TOLEDO - LUCAS COUNTY PLAN COMMISSIONS

TO: President Vanice S. Williams and Members of Council, City of Toledo
FROM: Toledo City Plan Commission, Lisa Cottrell, Secretary
SUBJECT: Special Use Permit for a New Community Center at 355 Dearborn Avenue
REF: SUP26-0017

APPLICATION #: **SUP26-0017**
APPLICANT: The Collaborative
OWNER: Toledo Public Schools (Purchase Agreement with Catholic Charities
Diocese of Toledo)
ADDRESS: 355 Dearborn Avenue
PARCEL(S): 18-67507
ZONING: RD6 (Duplex Residential)
NEIGHBORHOOD: Garfield
REPORT DATE: June 26, 2026
HEARING DATE: July 9, 2026
STAFF REVIEWER: Schultz

Proposed overall landscape plan for the new community center building.

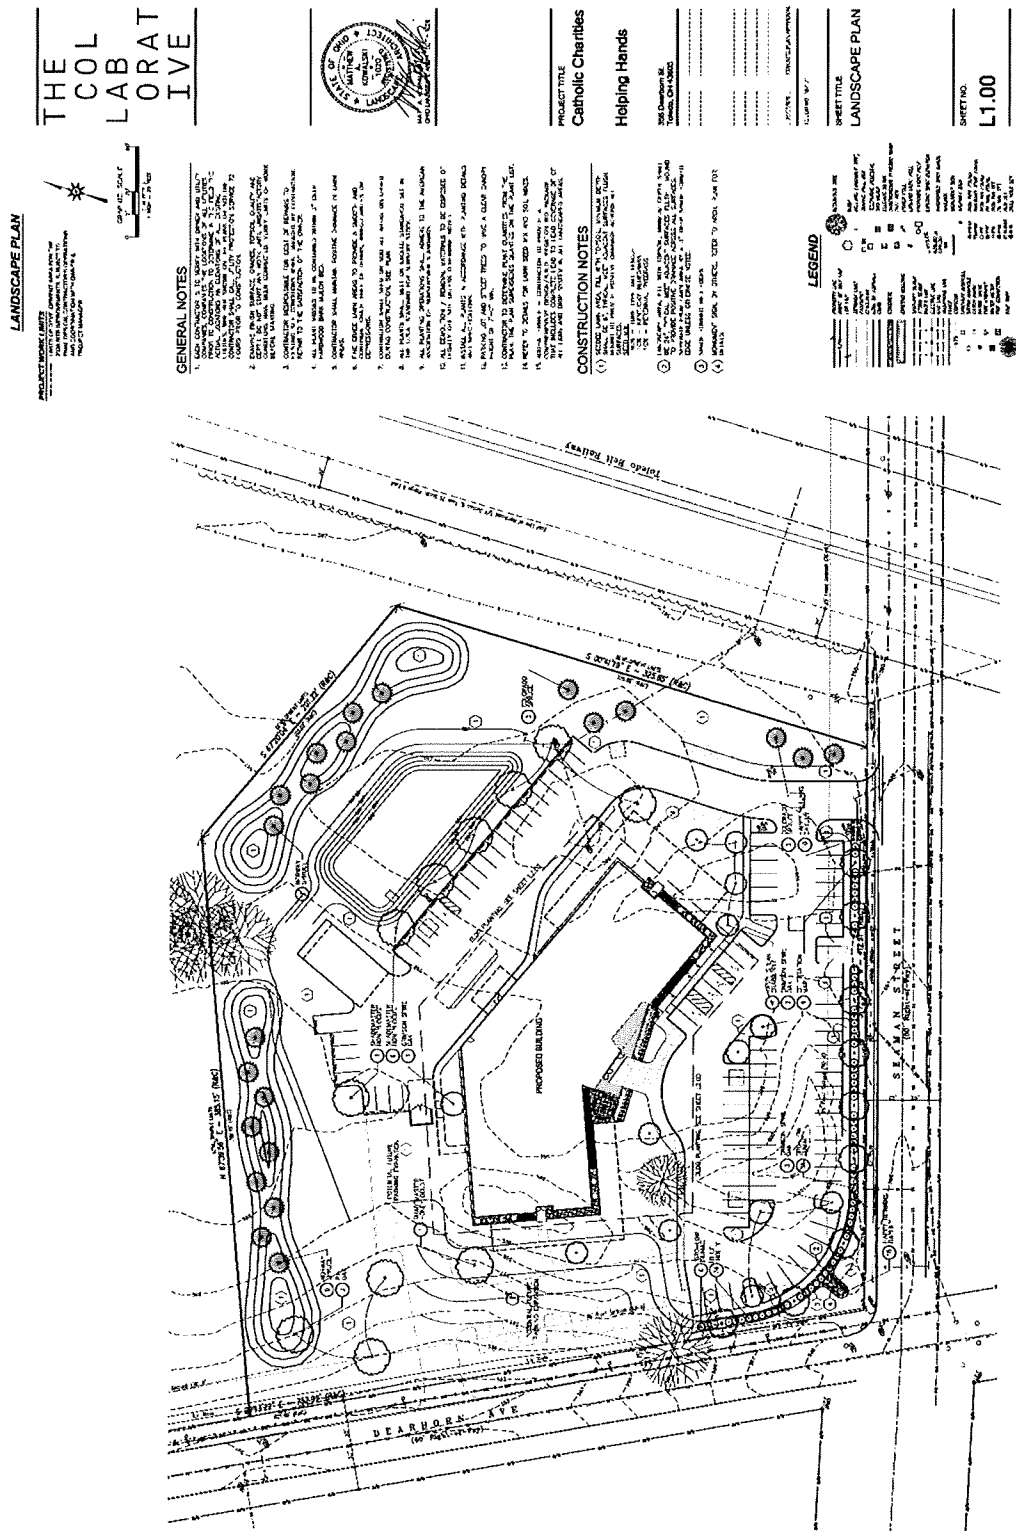
- (a) *1108.0202 Frontage Greenbelt.* A fifteen-foot (15') wide frontage greenbelt consisting of one (1) tree for every thirty feet (30') of frontage is required along both Seaman Street and Dearborn Avenue. A solid evergreen hedge is required where a parking lot is proposed in the front of the property. – Not acceptable as depicted. Frontage greenbelt trees are required along streets within the entire development limit, not just adjacent to parking areas. Fourteen (14) trees are required along Dearborn Avenue and twelve (12) trees are required along Seaman Street. Frontage greenbelt may need to be adjusted if right-of-way line is moved per Traffic Management's request.

- (b) *1108.0204 Parking Lot Landscaping (Interior).* All parking spaces must be within 100 linear feet of a landscape area. Landscaped terminal islands are required at the end of each parking row. Two (2) canopy trees and six (6) shrubs are required within these interior parking lot landscape areas for each ten (10) parking spaces. – Not acceptable as depicted. Landscape areas and number of trees is acceptable, but a minimum of sixty (60) shrubs is required within interior parking lot areas not including shrubs for frontage greenbelt screening or interior site landscaping requirements.

- (c) *1108.0403(C) Grass or Ground Cover.* Groundcover must be planted not more than 12 inches on center, in such a manner as to present a finished appearance. Rocks, pebbles, sand and similar materials are not approved groundcover. – Not acceptable as depicted. Proposed river rock groundcover is not permitted.

29. A fifteen-foot (15') wide frontage greenbelt consisting of one (1) tree for every thirty feet (30') of frontage is required within the project limits along both Seaman Street and Dearborn Avenue. A solid evergreen hedge is required where a parking lot is proposed in the front of the property. The applicant shall submit a revised landscape plan to the Plan Director depicting compliance with this condition.

31. Six (6) shrubs are required within interior parking lot landscaping areas for every ten (10) parking spaces. The applicant shall submit a revised landscape plan to the Plan Director depicting compliance with this condition.

32. Proposed river rock groundcover shall be removed and replaced with an acceptable material. The applicant shall submit a revised landscape plan replacing the proposed ricker rock.

Rendering of the proposed community center building.

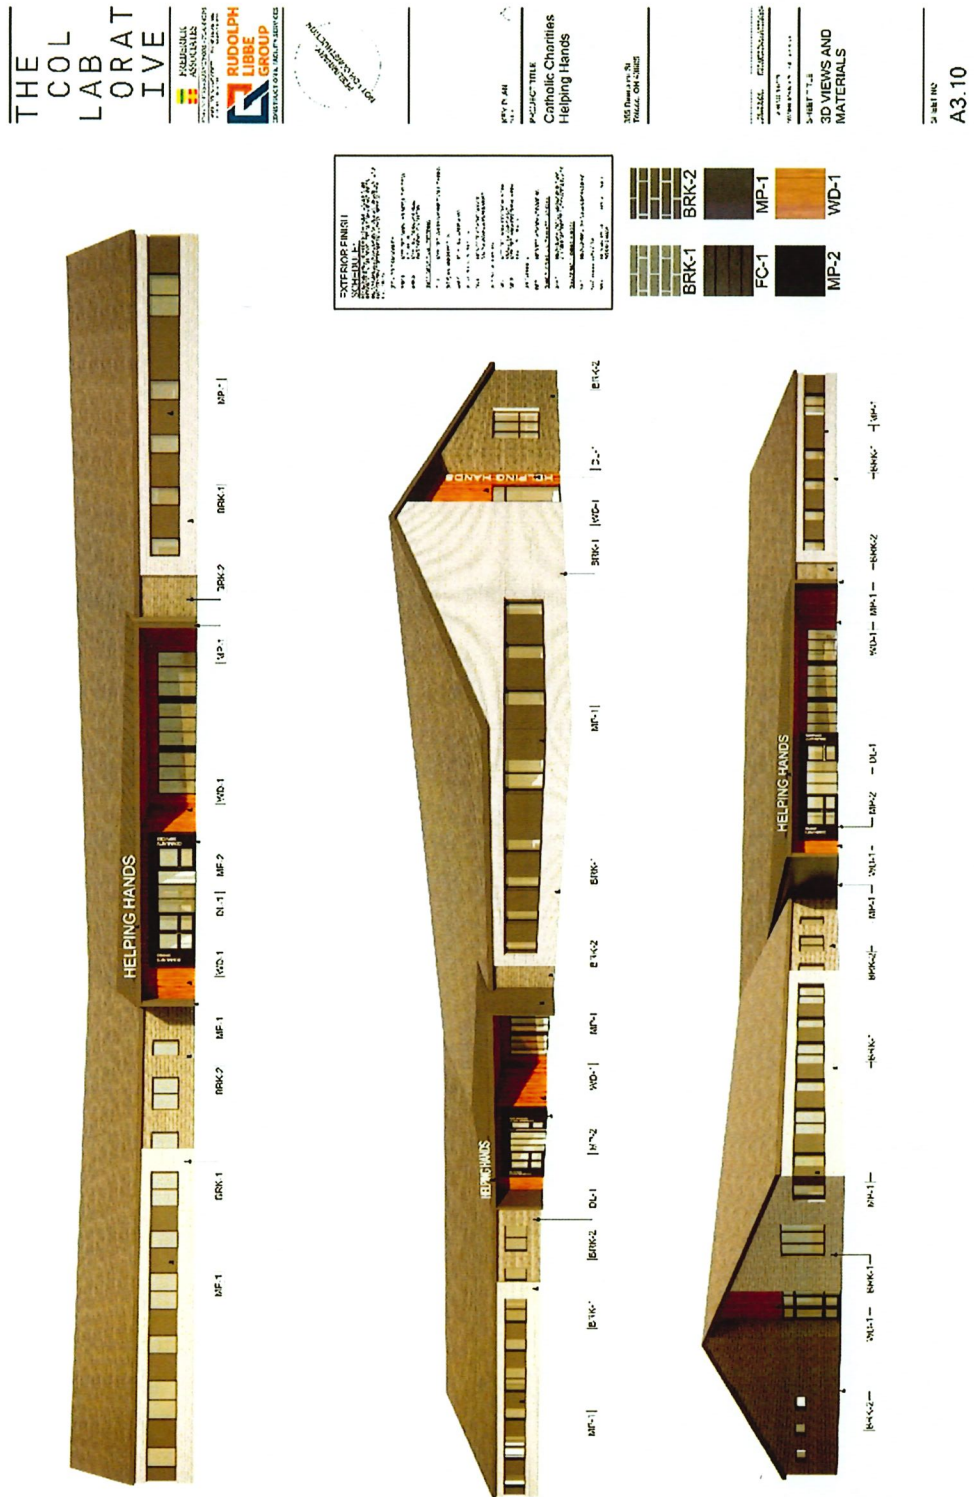
- (a) *1113.0102 Permit Required.* All proposed signs shall obtain a separate sign permit. – Such proposed signage shall meet the requirements of Chapter 1113.
- (b) *1113.0304 Building Sign Standards.* No building sign may extend above the height of the building. – The depicted sign above the main entrance is not acceptable.

35. The applicant shall submit a revised site plan to the Plan Director depicting pedestrian crosswalks that are distinguished per TMC§1109.0204(A).
36. Any proposed signage shall obtain a separate sign permit meeting the requirements of TMC Chapter 1113. Some currently-depicted signage does not meet the requirements of TMC Chapter 1113.
